Service Bulletin

Bulletin No.: PIP5009D

Subject: Replace The Internal Transmission Wiring Harness And TCC Enable Solenoid Anytime The Transmission Is In For Service Malfunction Indicator Lamp (MIL) With DTC P0741 Set And Harsh 1-2 Shift Built between 10/01/11 And 4/30/12

Models: 2012 Chevrolet Colorado, Express, Silverado
2012 GMC Canyon, Savana, SierraAll
Equipped with Automatic Transmission 4L60E (RPO M30)
Built between 10/01/2011 and 04/30/2012

2854421

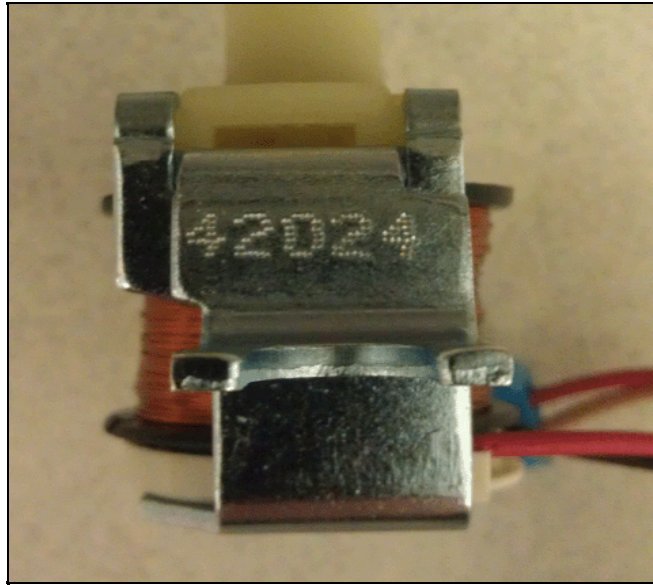
Note: To prevent multiple TCC Enable Solenoid and Wire Harness replacements check the five digit date code on the TCC Enable Solenoid body to see if it has been replaced.

The first digit (month of build) should be a 4 or higher or an alpha character. The fourth digit should be a 2 (calendar year 2012). Example: 42024 shown in the picture below.

If the first digit is a 4 or higher or an alpha character (month of build) and the fourth digit is a 2 or greater (calendar year 2012) it does not need to be replaced.

Important: Replace the TCC Enable Solenoid and Wire Harness part number 24237980 anytime repairs are being performed on the transmission on vehicles manufactured between 10/01/11 and 4/30/12.
